Description: ONE, TWO STOREY SIDE / REAR EXTENSION AND
ALTERATIONS.

One/Two Storey Side/Rear Extension and Alterations
At 61 Downside Road, Sutton

NOTICE OF REJECTION OF PLANS Building Act, 1984 and the Building Regulations, 2000

One, Two Storey Side/Rear Extension and Alterations at 61 Downs Road, Sutton

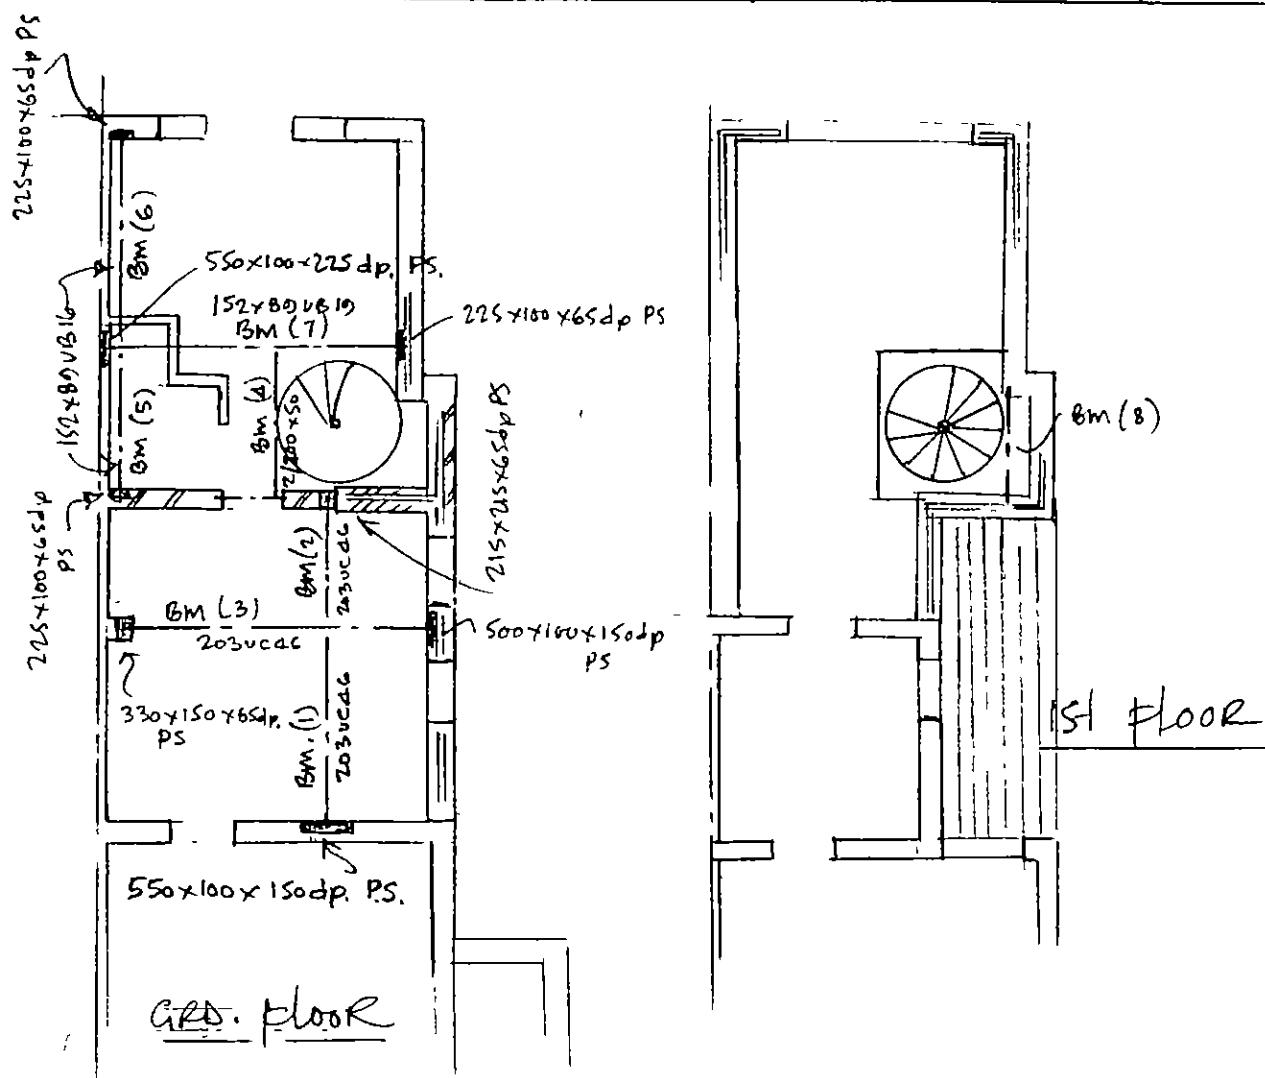
Please send to S.O.
for check with file
No. 7884 Thank
you

61 Downs Rd., Belmont.

Ⓐ - colors for steel.
- colors for eccentric wooden flood

Ⓑ, Ⓛ Ⓝ - Ⓞ - Ⓟ Ⓠ? Ⓡ Ⓢ? several slis.

Ⓒ, Ⓣ - Ⓤ, Ⓥ?
